Service Campaign Bulletin

Campaign No. 2017020019, August 2017

SUBJECT: **Model 166, Model Year 2016 - 2017**
Replace Fasteners for Rear Axle Camber Adjustment

Figure 1

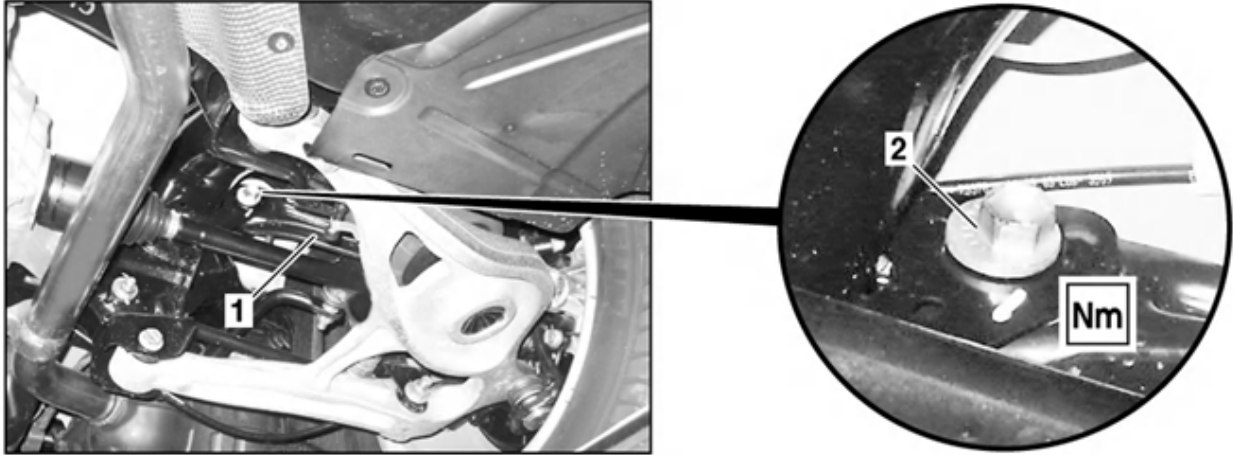
Daimler AG ('DAG'), the manufacturer of Mercedes-Benz vehicles, has determined that on certain GLS-Class (166 platform) vehicles, the threaded connection for the camber adjustment on the left and right of the rear axle does not correspond to specifications. The screws' anti-corrosion protection may have been worn during assembly. As a result, the threaded connection may no longer be correctly tightened during subsequent camber adjustments. An authorized Mercedes-Benz dealer will replace the left and right threaded connections on the affected vehicles.

1.  Replace bolt and nut (2) of tie rod (1) for rear axle (figure 1).
